SERVICE BULLETIN

NEW CHARGING COIL ASSY. WITH SUPPORT FOR ROTAX® ENGINE TYPE 535 SB-535-008 R1

fig.1

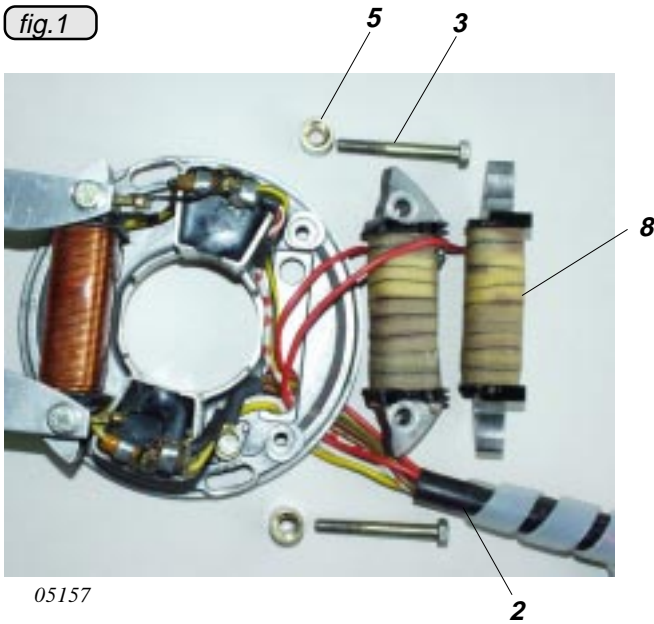
- Draw in the red charging cable (6) by a commonly used trace-wire through the insulation hose (2) or screening braid and position the charging coil (8) on the armature plate (1) (see fig. 1).

fig. 2

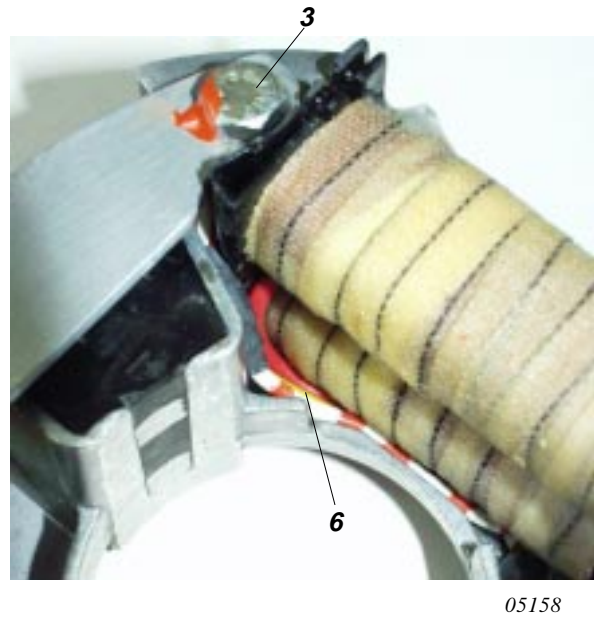
■ **CAUTION:** To prevent squeezing of the charging cable (6) route the cable parallel below the charging coil (see fig. 2).

fig. 3

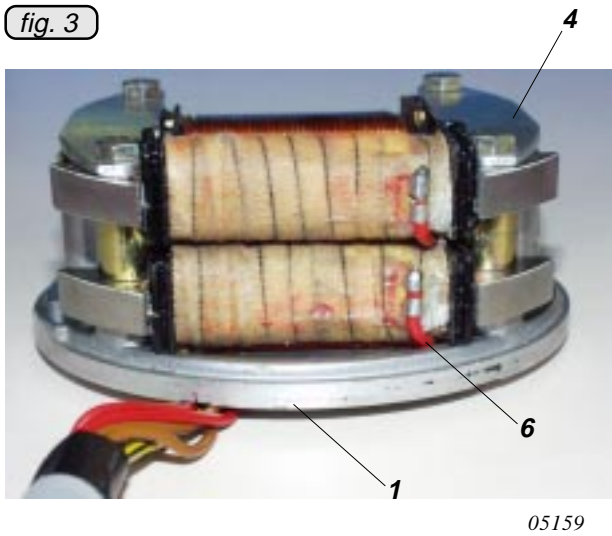
■ **CAUTION:** On the new charging coil (8) the wiring direction of the coil have been turned round, therefore the positioning (position of the charging cable 6) need to be followed as shown in fig. 3. At wrong installed charging coil no high tension output of the relevant electronic box and therefore no ignition spark will be created.

fig. 5

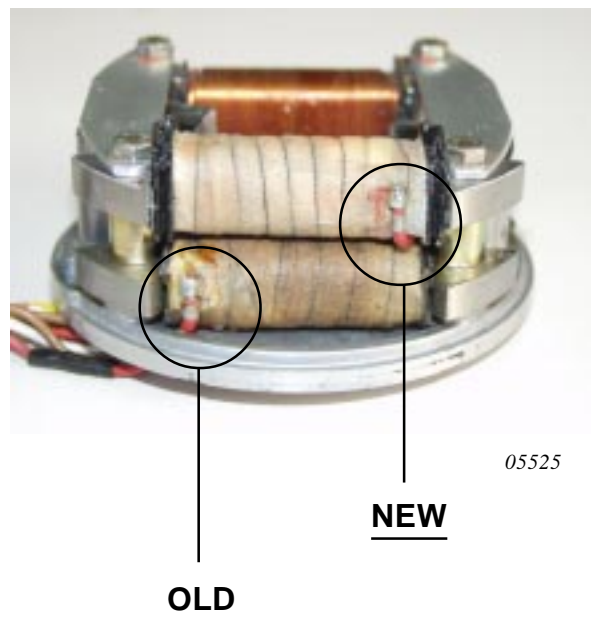
- At replacement of charging coil(s) the armature support has to be renewed too. This is included in the supply volume.
 - An old type and new type charging coil may be fitted together as a working pair (one old style and one new style on same armature plate), but additional care needs to be put on changed positioning of the new charging coil.
- ◆ NOTE: Because of changed wiring at the new type charging coil assy the charging cable soldering point is opposit on the right side (see fig. 5).

If an old type and a new type charging coil is fitted together as a working pair, the charging cable soldering points are at the opposite side (see fig. 5).
